DS-K5671 Series MinMoe Terminal Release Notes (2022-03-09)

Device Model: DS-K5671-ZV/ZH/ZU	Firmware Version	ARM: ACS_671_AI3_EN_STD_V3.2.0_build220210 ACS_671_AI3_EN_NEU_V3.2.0_build220210
	SDK	Latest version
	iVMS-4200 Version	Latest baseline

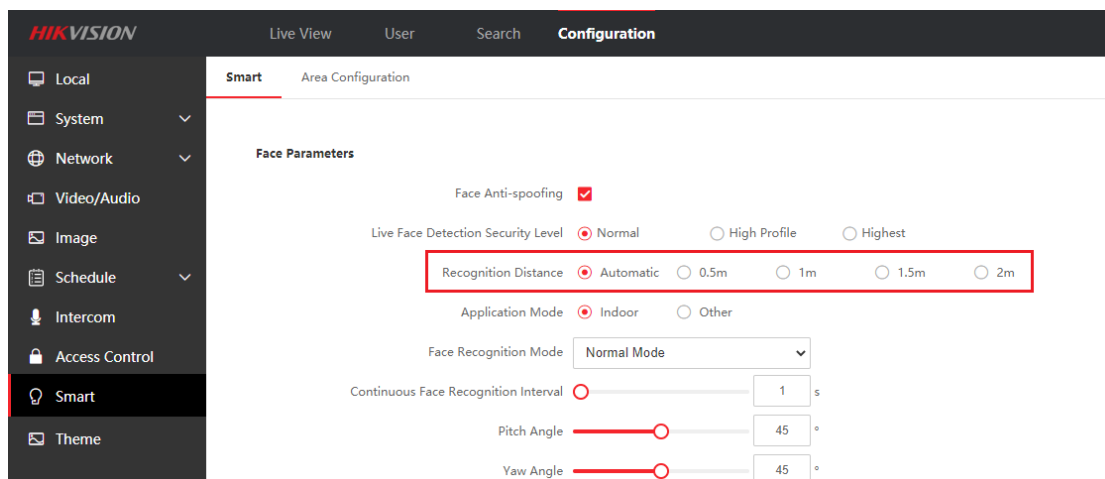
1. Add Hik-Connect menu in device UI Menu → Comm. The function is disabled in default.

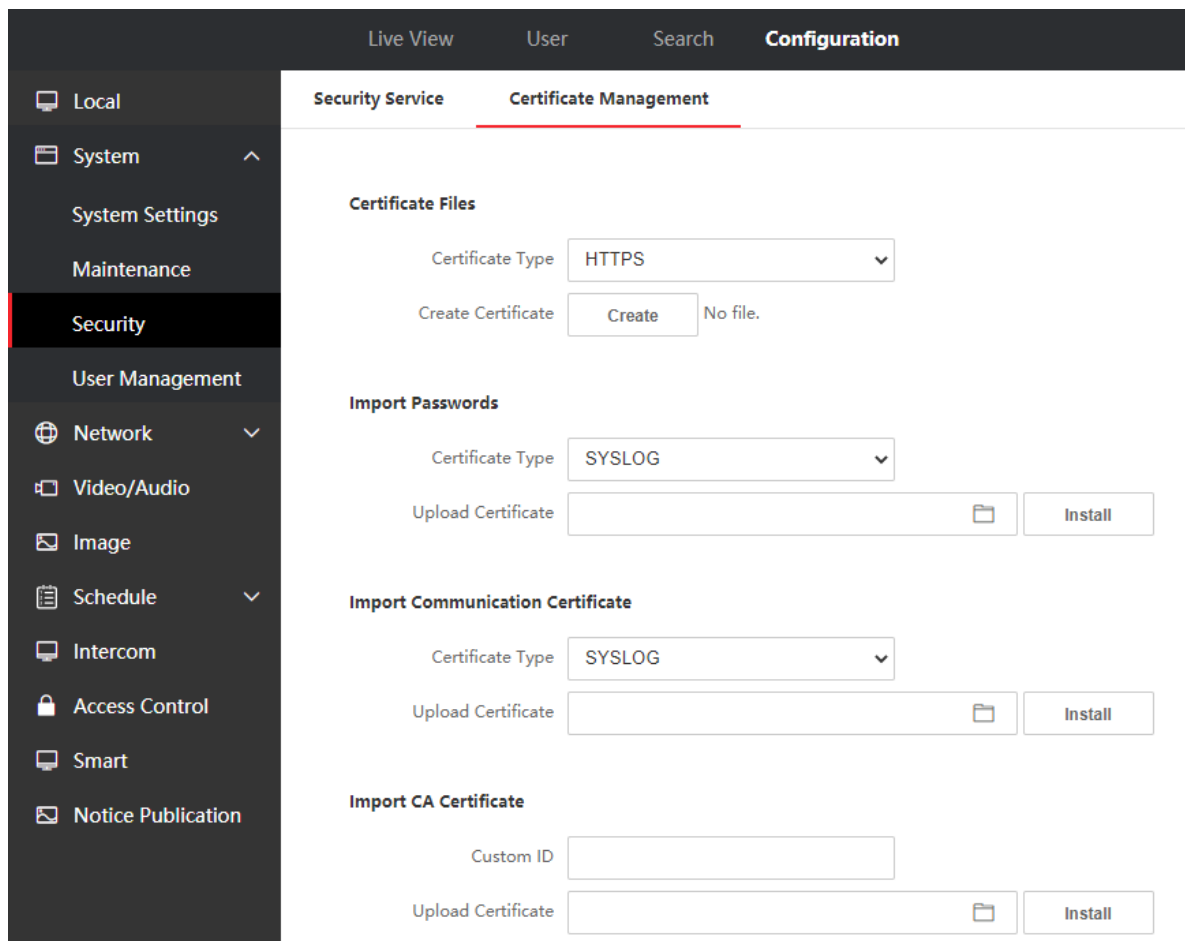
1. Support https feature

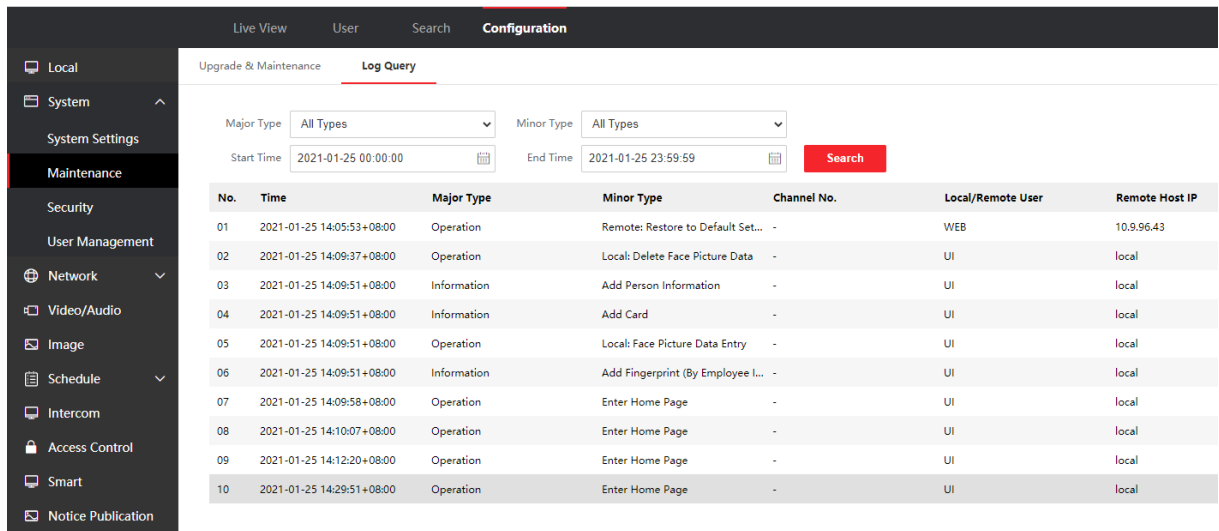
5. Add device operation log query function

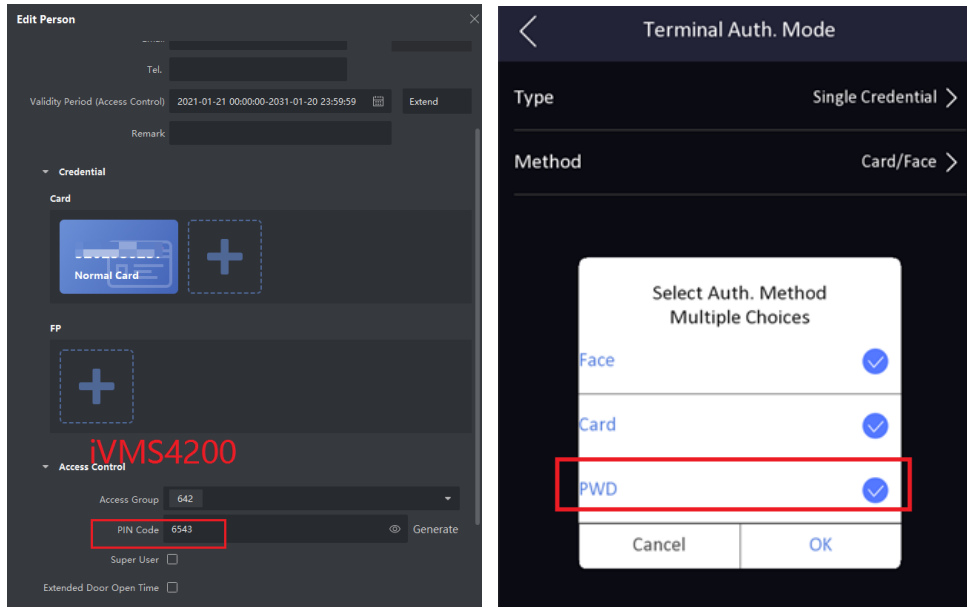
7. Support PIN code to open the door (disabled in default)

Note: PIN code should be configured from software, iVMS4200 already support, HikCentral Pro will support PIN code configuration in V2.1 expected to be released in June

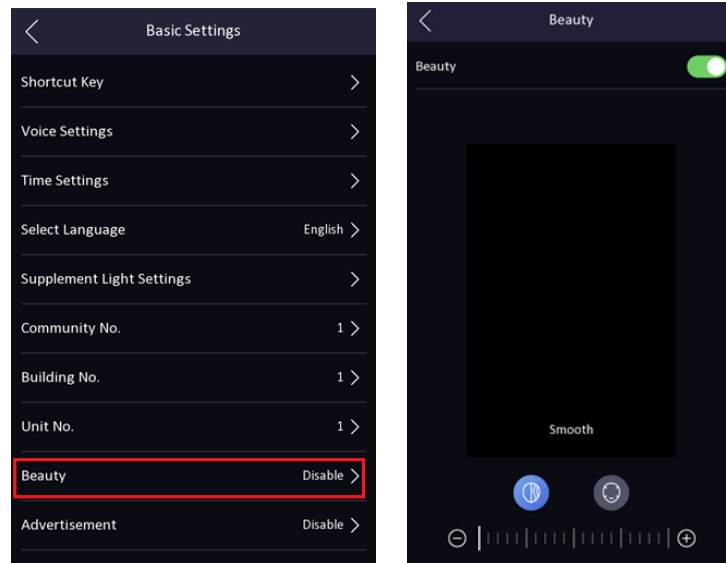
9. Add beauty function to adjust smooth and whiten parameter.

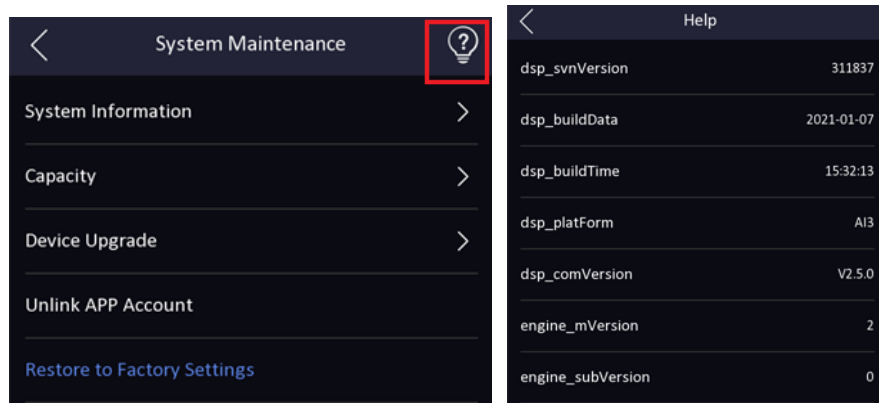
10. Add help interface to check system module version for technical support (long press for 3s).

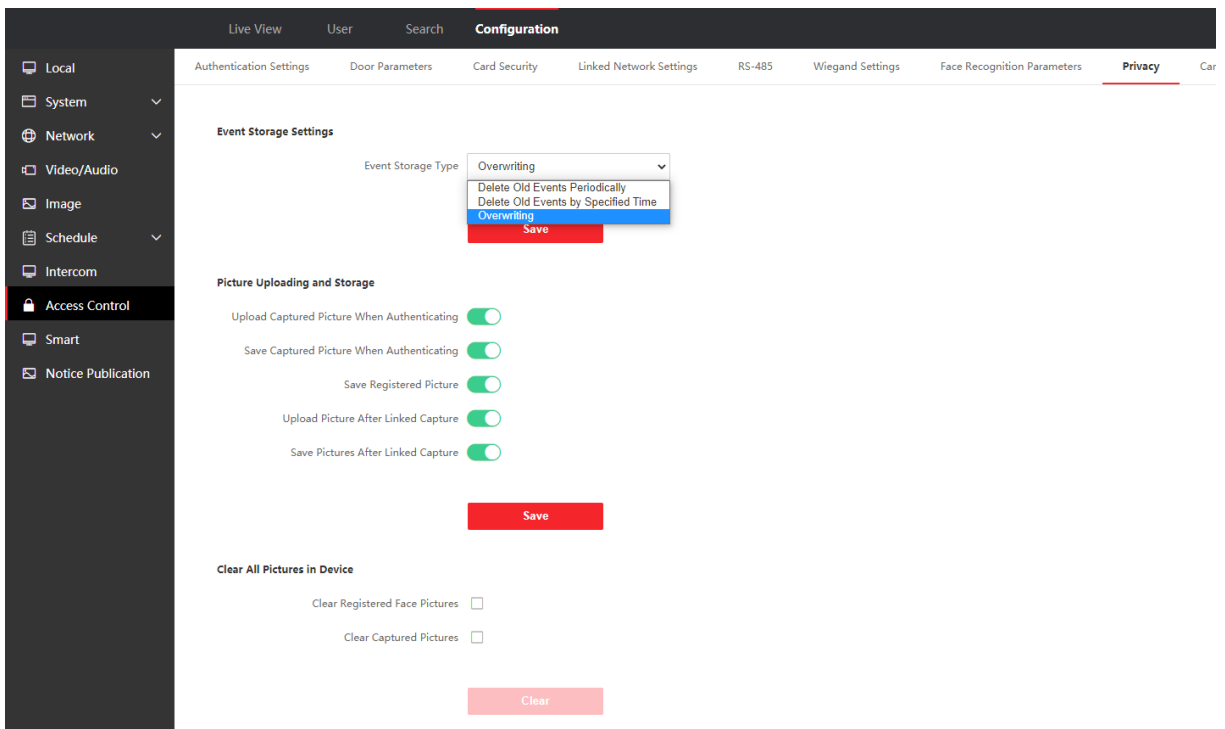
11. Add privacy protection, customer can define the privacy related parameter, such as Event Storage Settings, Picture Uploading and Storage, Clear All Pictures in Device

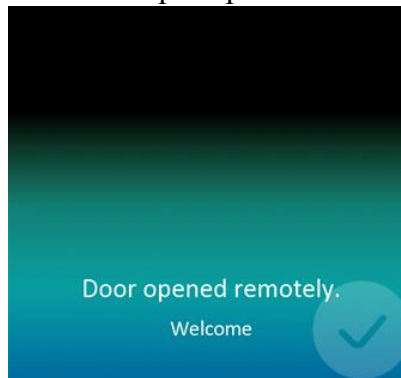
13. Add audio prompt 'The door is open' when open door on iVMS4200, HikCentral Pro, Hik-Connect App, and device UI will show prompt

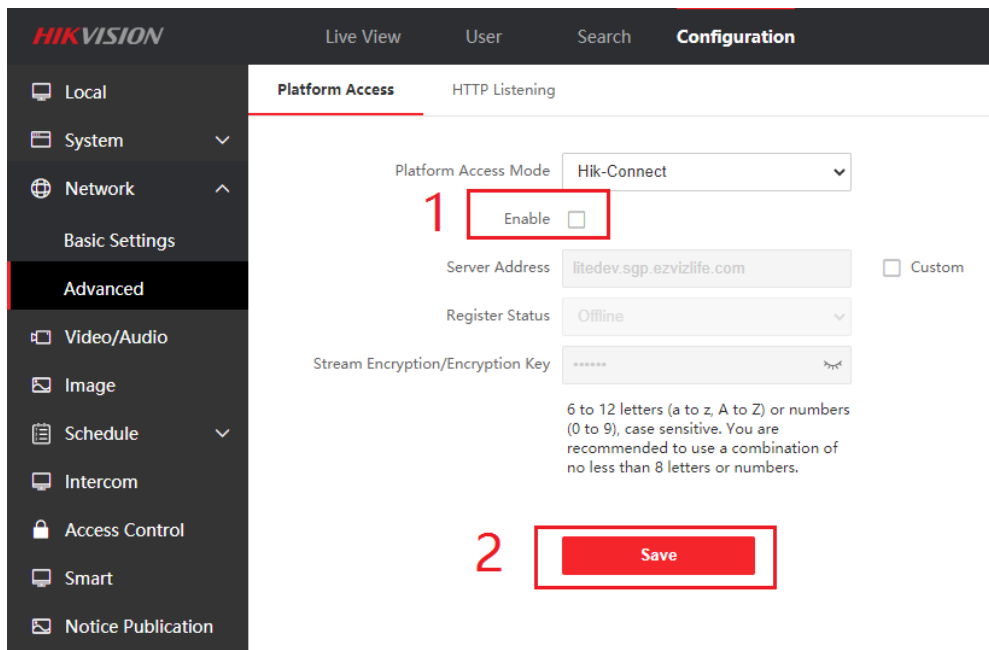
3. Hik-Connect function is turned off in default for privacy protection, if customer want to manage device from App, please turn on manually in the web.

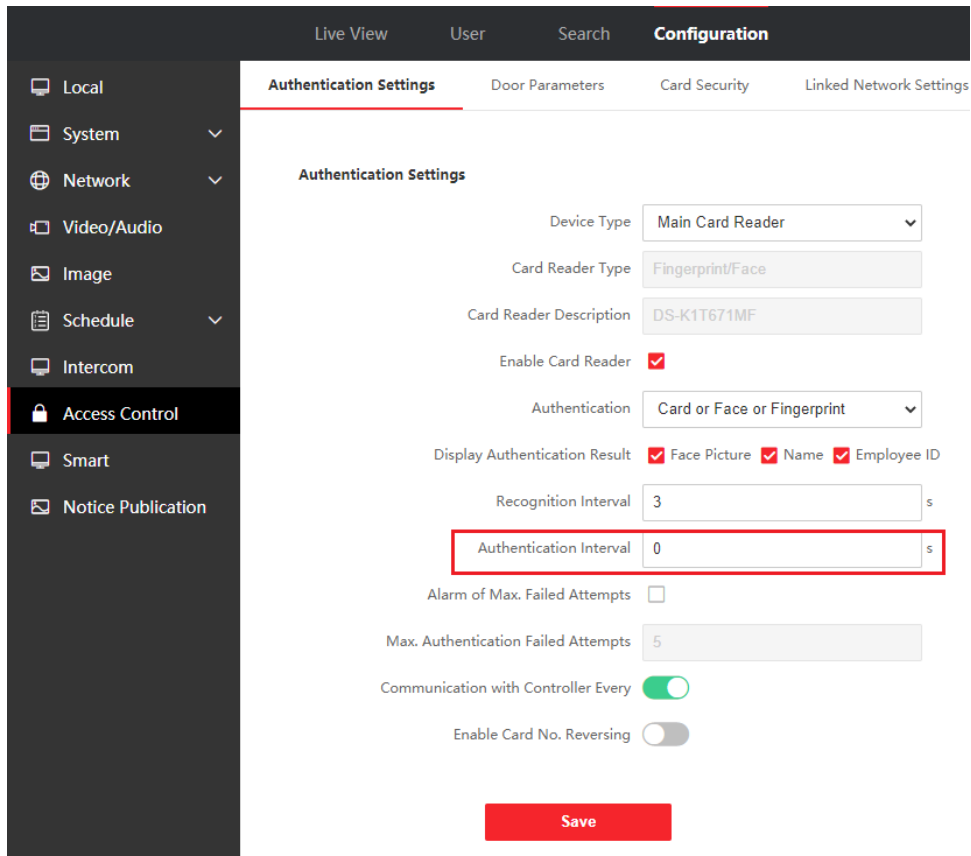
- 6. Optimized the ISUP and Hik-Connect event upload mechanism.
- 7. Add stranger authentication timeout time configuration

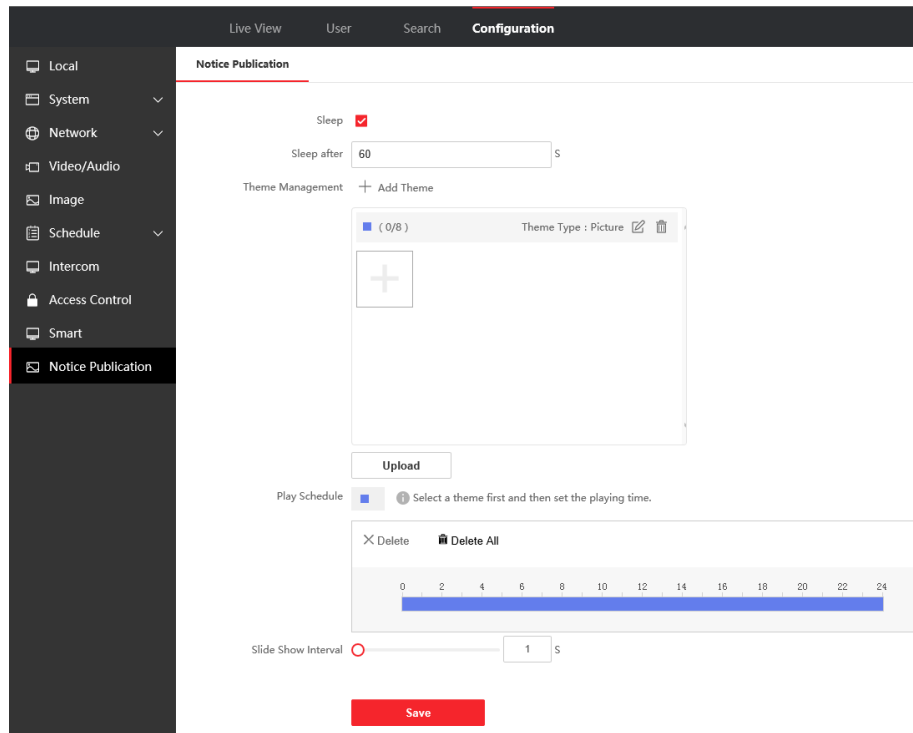
- 8. Add advertisement/wallpaper play schedule configuration, slide show interval.
